Safety Evaluation Report

Related to the Northwest Medical Isotopes, LLC
Construction Permit Application for a Production
Facility

Docket No. 50-609

November 2017 (As revised January 2018)

Figure 13.4.10 - 1 Scaled Distance-Overpressure Relationship

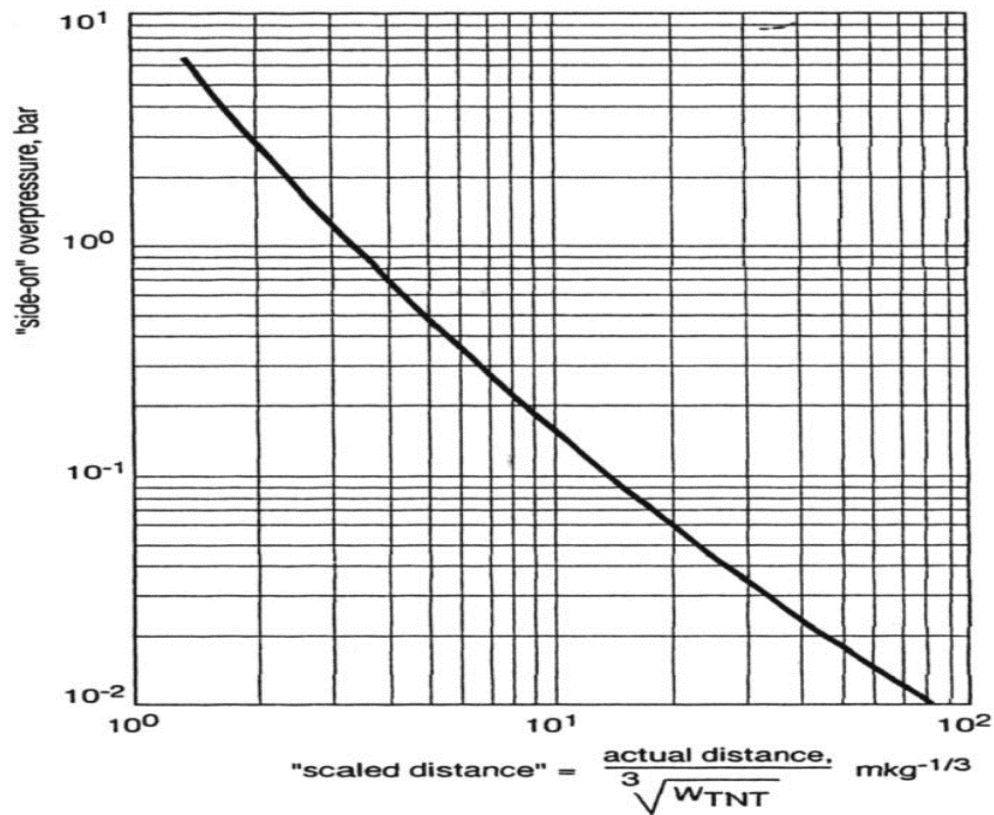
(TNT)-equivalent explosion to “side-on” overpressure that the nearest confinement barrier would experience. This correlation between scaled distance and overpressure is commonly found in the literature evaluating the effects of explosions.³ SER Figure 13.4.10-1, “Scaled Distance-Overpressure Relationship,” shows this distance-overpressure relationship. The use of this relationship is generally considered to be conservative because the energetic ion exchange reactions can often proceed at a slower, non-explosive rate resulting in reduced overpressures.
